Please see below the response prepared on behalf of the applicant to comments received for application 2019/3818/L on 27/10/2019, 12:49:29.

Image O1
View from ground floor of no.2
Fitzroy Square

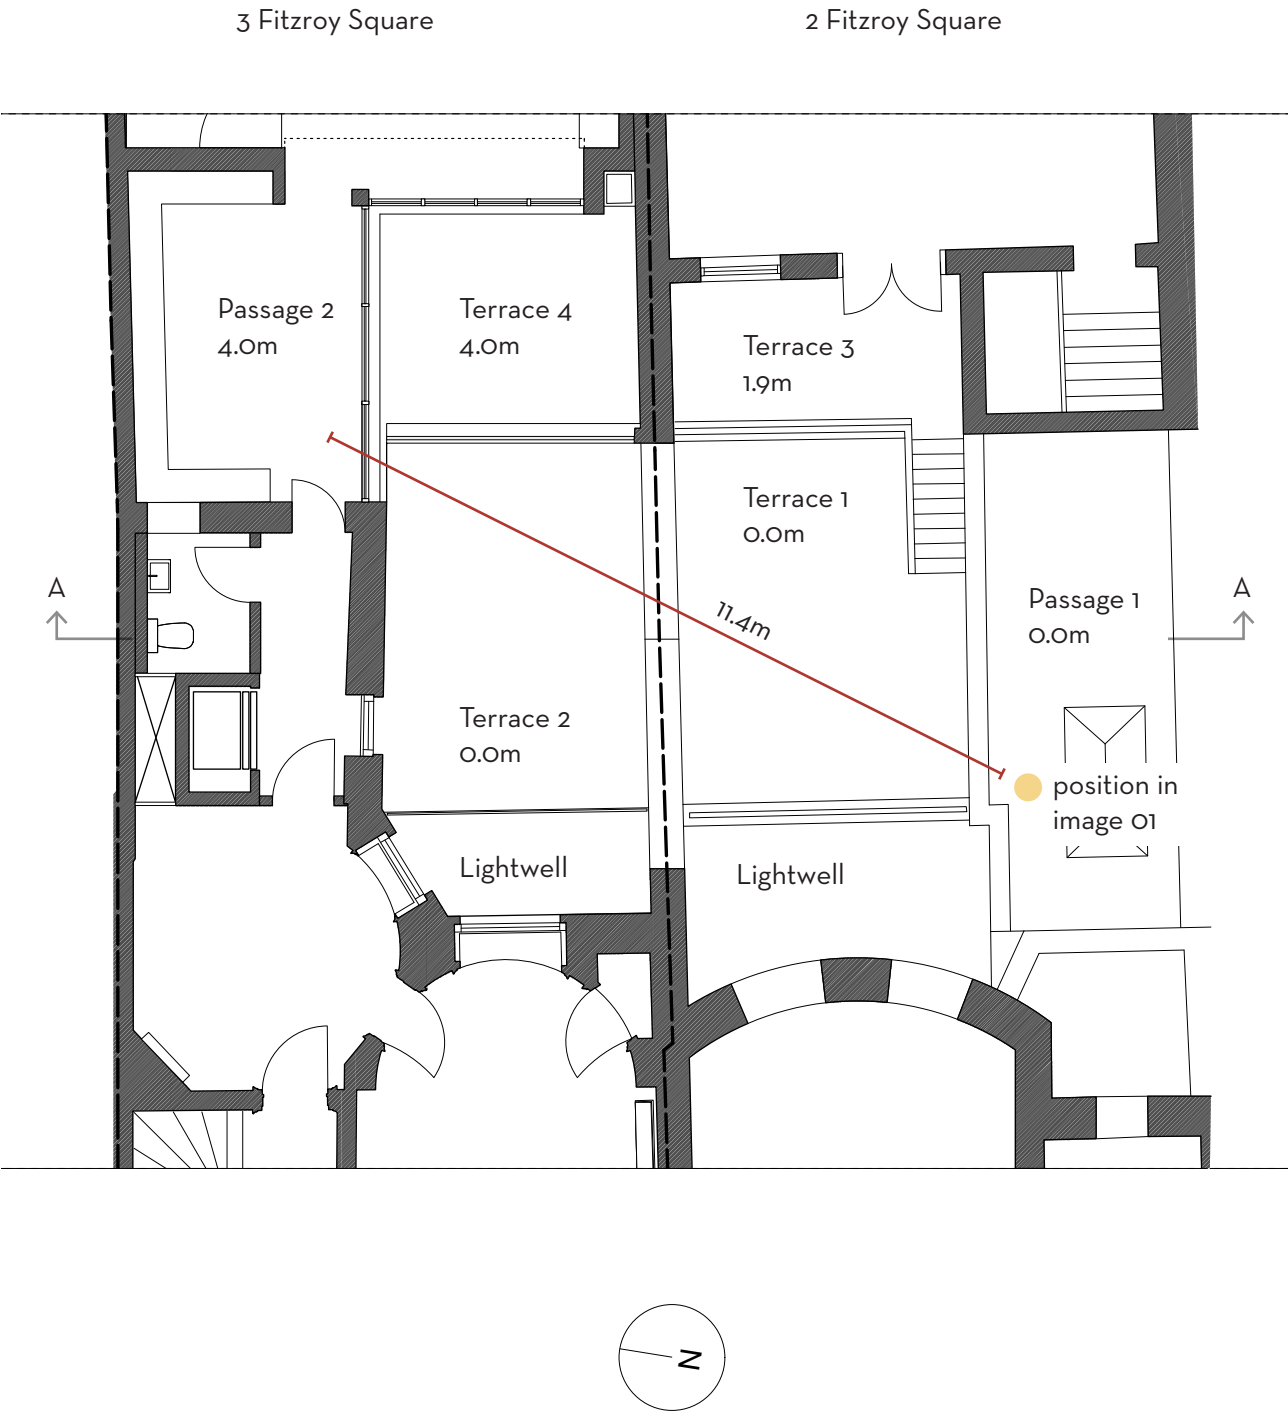
"The proposed amendments... will severely overlook both the internal room and external amenity spaces of 2 Fitzroy Square at very short distances and from above."

"...this newly proposed extension significantly increases the overlooking of our property and blocks virtually all of the sky that can be seen in the right-hand picture."

The proposed walkway is 11.4m from the viewer's position in image 01, the viewer's position is within a corridor space, the proposed walkway will also primarily be used as a circulation space and the proposed walkway does not directly face any of the neighbouring windows to habitable rooms (see plan 01 below).

The distance between windows is almost equivalent to the width of Grafton Mews and was therefore not considered to be a short distance. The spaces are both primarily circulation spaces. The windows are not directly facing and are not on the same level which means there is no obvious relationship between them.

The proposed walkway will not have any impact on the visible sky from the position indicated (in image 01). Parapet 1 behind is significantly higher than the proposed walkway and will remain the primary obstruction to the visible sky from this position.
